CITY OF BIDDEFORD

STAFF REVIEW COMMITTEE REPORT

RE: **2020.14 Site Plan Review for James Godbout to construct a 5,000 square foot storage building and associated site infrastructure at 486 Elm Street (Tax Map 18, Lot 29) in the B-2 Zone.**

PROPOSED
ELEVATIONS

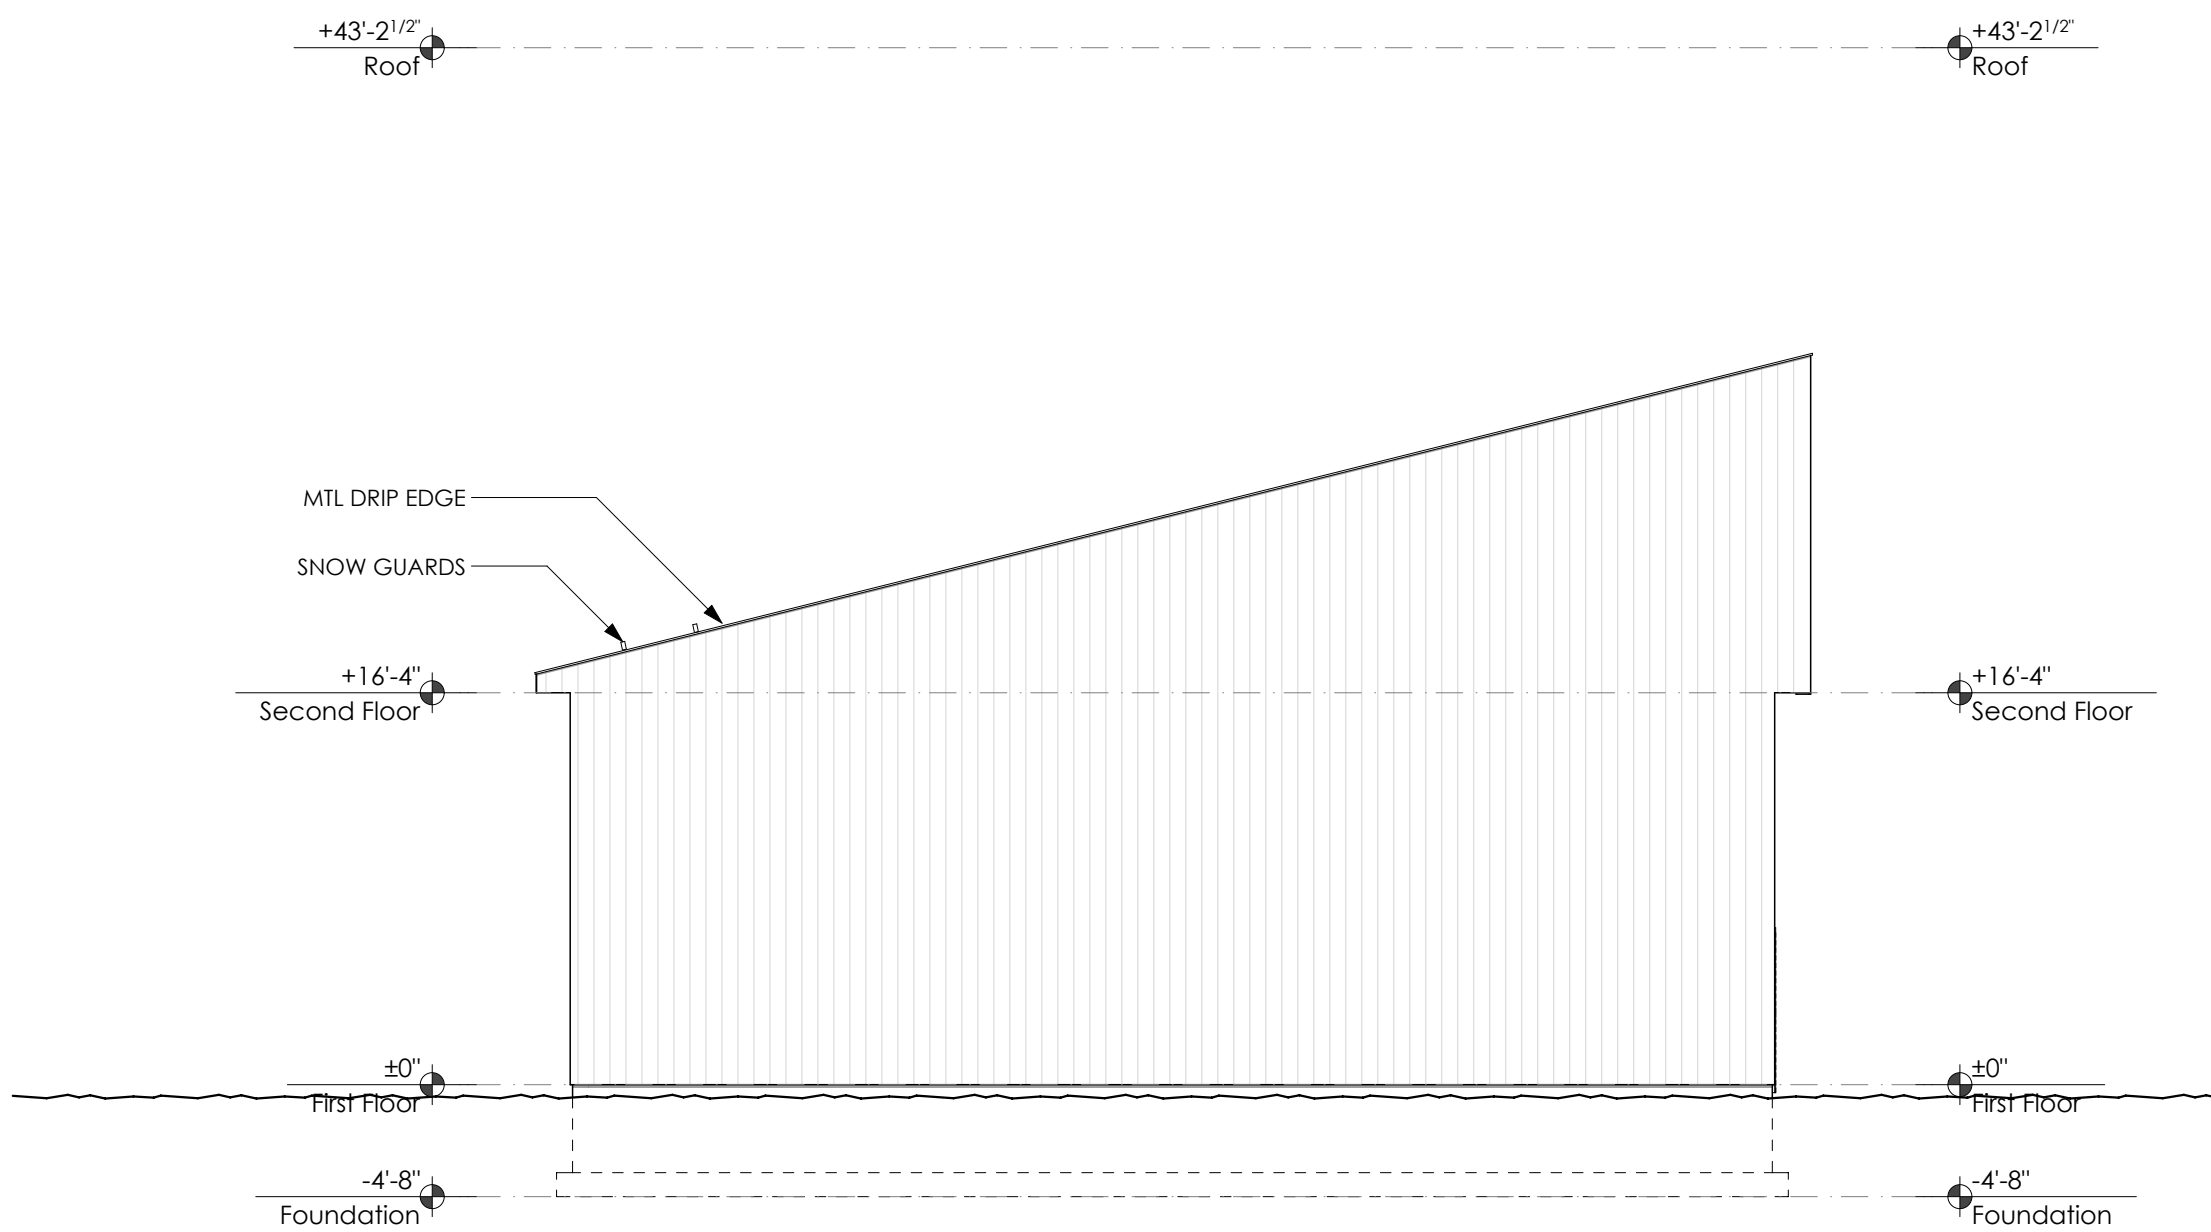
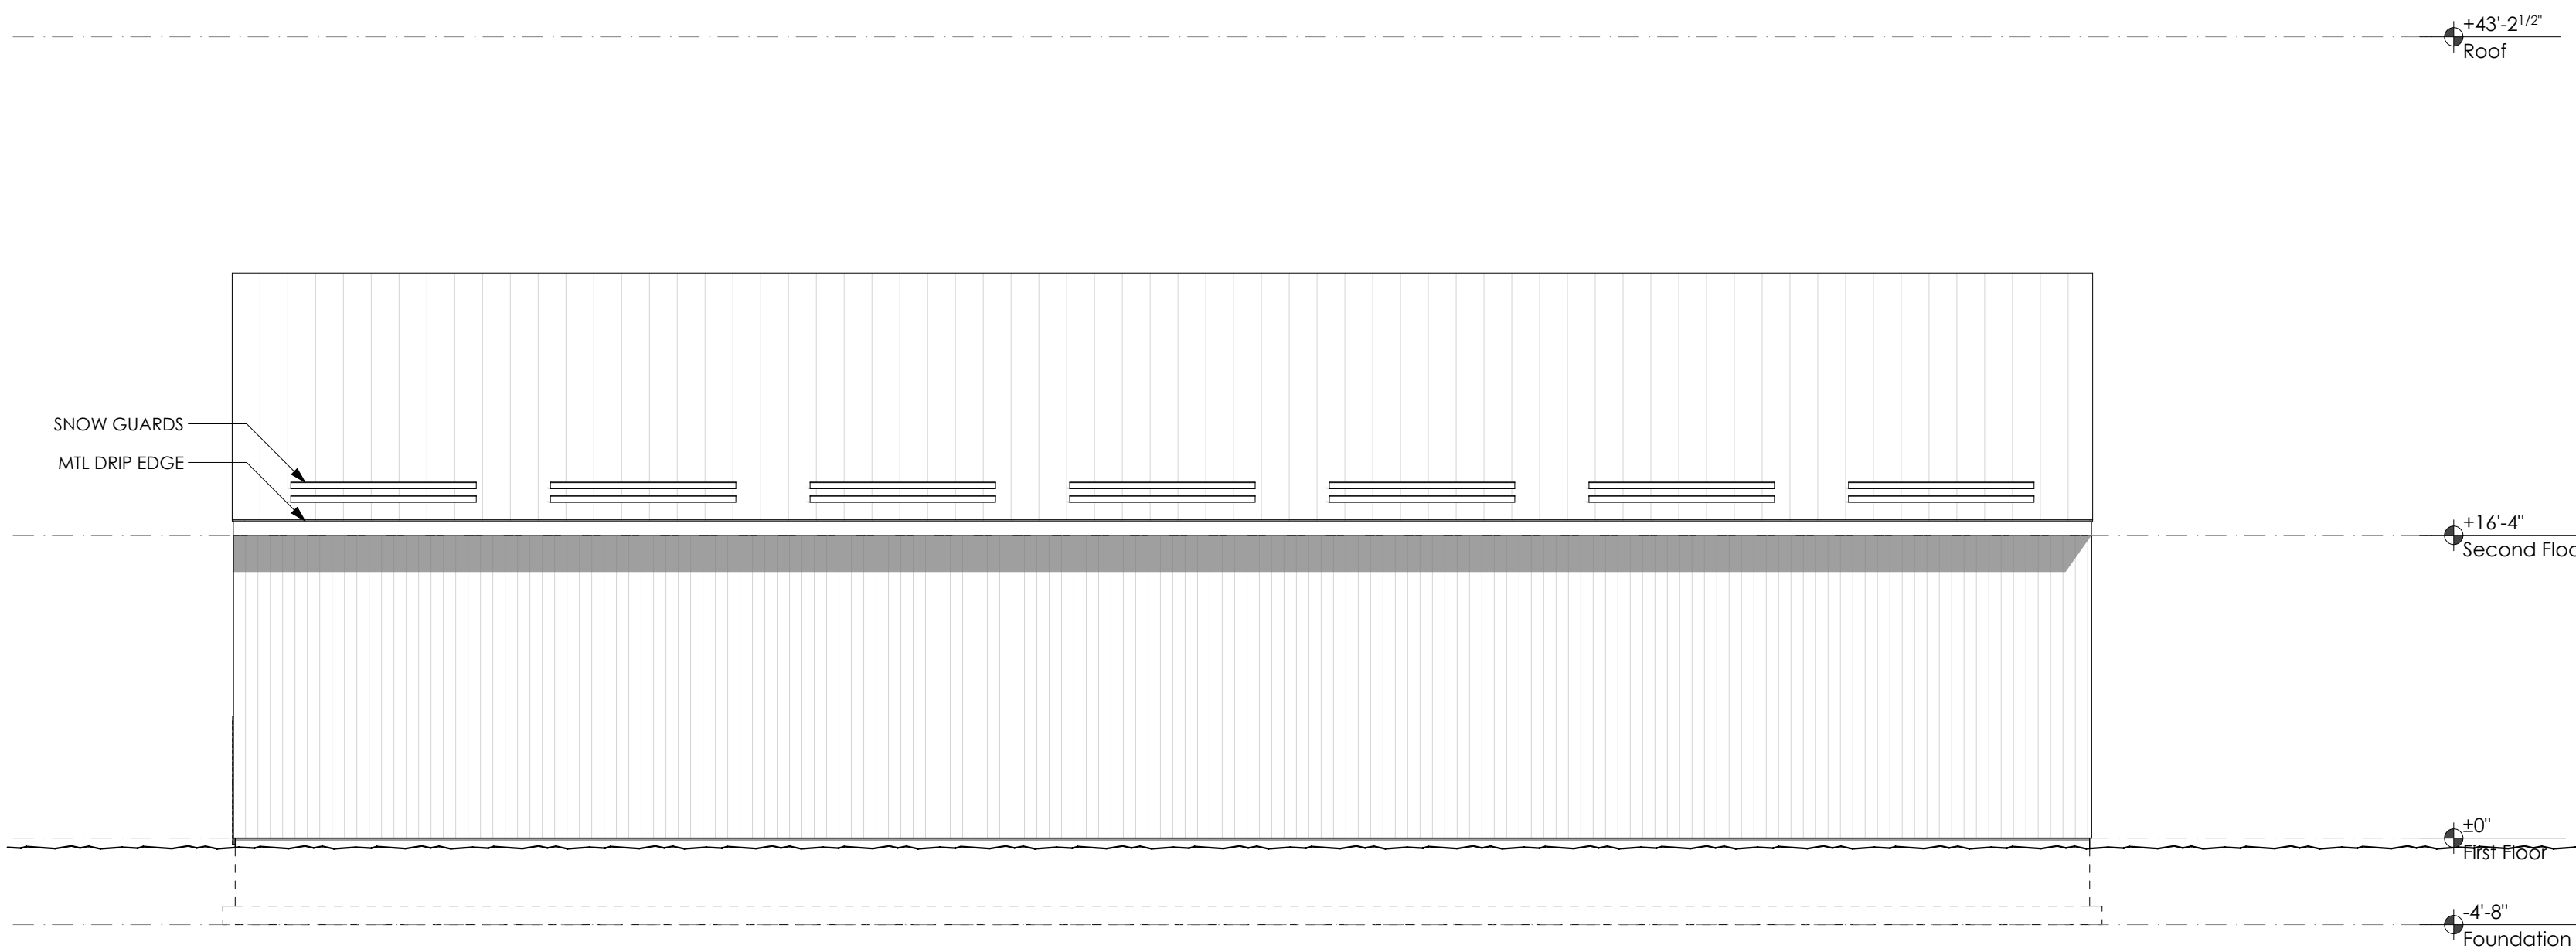
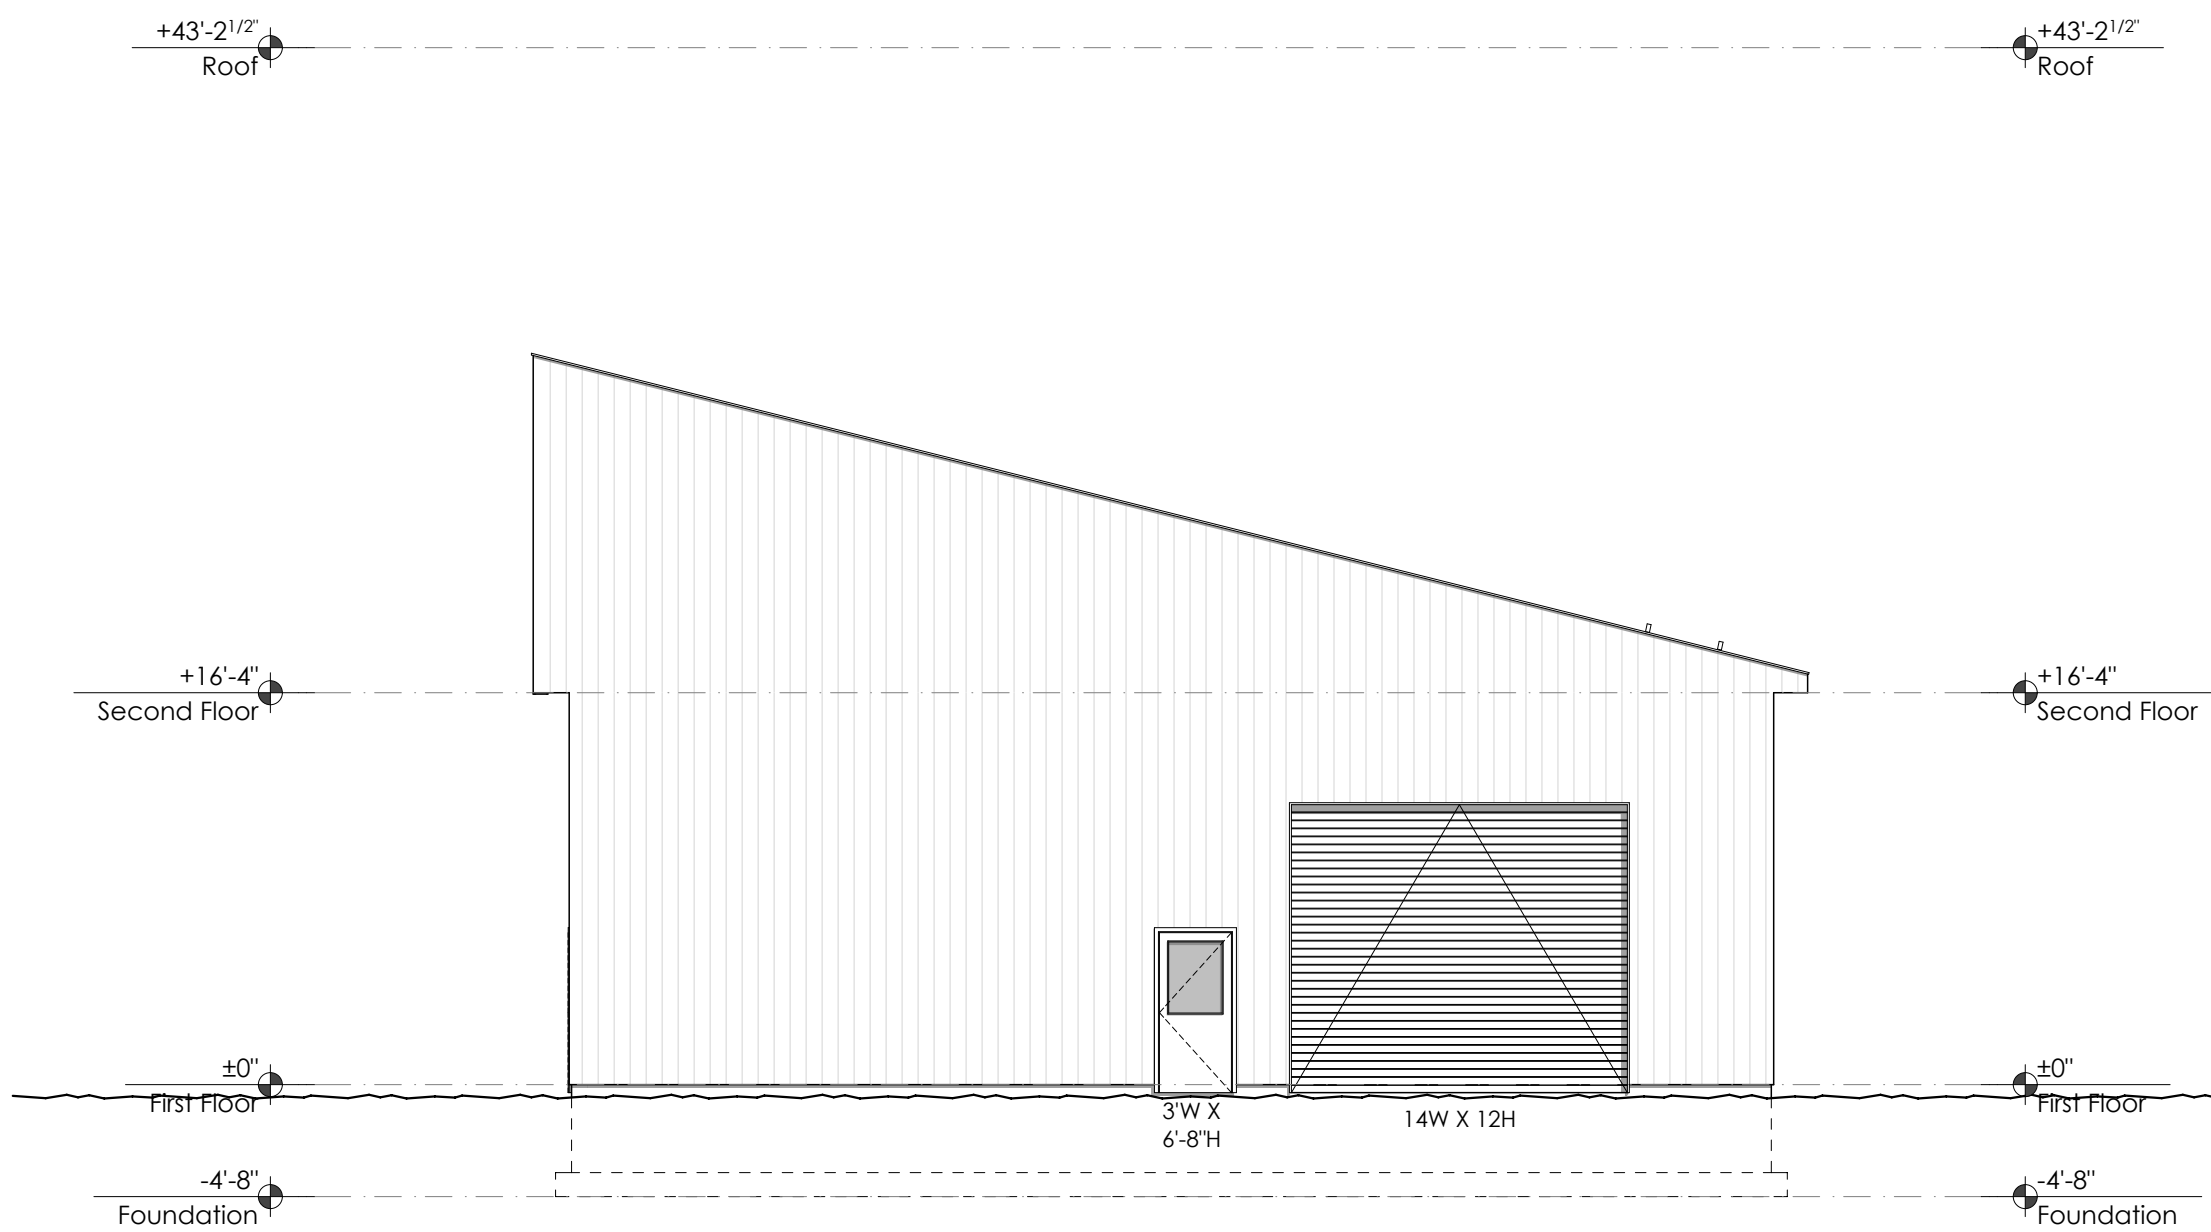
- d. Police Department Review (Potential E-911 Addressing) – Contact Deputy Chief JoAnne Fiske
6. Building elevations – provide colors and perspective of the building as viewed from the street and from neighboring abutters (presume vegetation removal is complete). How will this complement the existing building on the site and the neighboring residential neighborhood?
